AMENDMENTS TO THE DRAWINGS:

Attachment(s): Replacement Sheets (Figs. 1, 2)
 Annotated Sheet Showing Changes (Figs. 1, 2)

Fig. 1

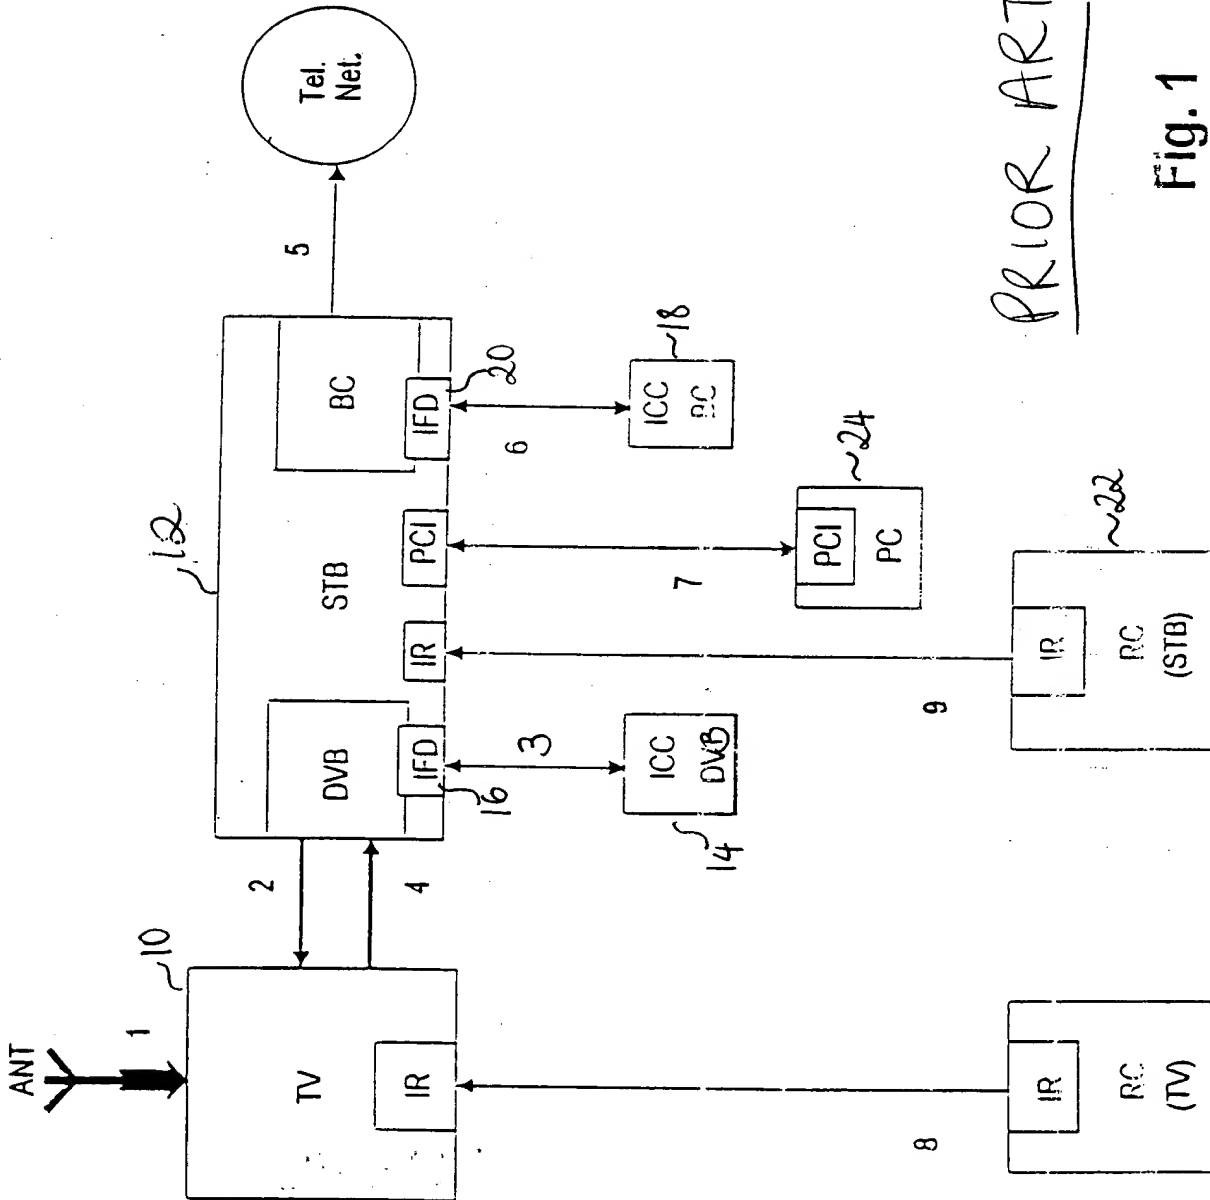
The attached sheet of drawings includes changes to Figs. 1 and 2. The sheets of Figs. 1 and 2 replace the original sheet of Figs. 1 and 2, respectively. In Fig. 1, STB “72” should read “12” in accordance with the Specification. Further, Fig. 1 should be labeled “Prior Art.” In Fig. 2, DVB “42” should read “45” in accordance with the Specification.
